Contract #: 04-0120F4Cty: SF/ALA Rte: 80 PM: 13.2/13.9File #: xx.28**WELDING INSPECTION REPORT****Resident Engineer:**Siegenthaler, Peter**Address:** 333 Burma Road**City:** Oakland, CA 94607**Report No:** WIR-026012**Date Inspected:** 27-Jun-2011**Project Name:** SAS Superstructure**OSM Arrival Time:** 700**Prime Contractor:** American Bridge/Fluor Enterprises, a JV**OSM Departure Time:** 1900**Contractor:** Zhenhua Port Machinery Company, Ltd (ZPMC), Changxing Island **Location:** Shanghai China**CWI Name:** Mr. Liu Huajie**CWI Present:** Yes No**Inspected CWI report:** Yes No N/A**Rod Oven in Use:** Yes No N/A**Electrode to specification:** Yes No N/A**Weld Procedures Followed:** Yes No N/A**Qualified Welders:** Yes No N/A**Verified Joint Fit-up:** Yes No N/A**Approved Drawings:** Yes No N/A**Approved WPS:** Yes No N/A**Delayed / Cancelled:** Yes No N/A**Bridge No:** 34-0006**Component:** OBG Trial Assembly**Summary of Items Observed:**

Visual Inspection after Blast at OBG Segment 14 East.

Location 1

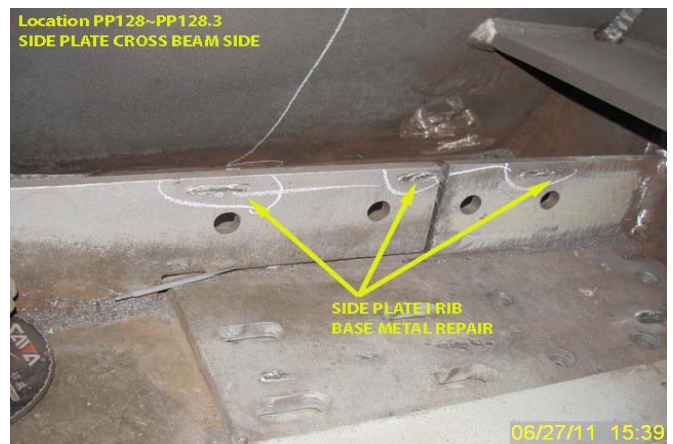
In between PP127 and PP127.5 a base metal repair was visibly observed on the bottom Plate one (01) location and side plate two (02) location and one location stiffener cut area of EB3053A, base metal repair approx 1Meter. On cross beam side of segment, Areas were marked.
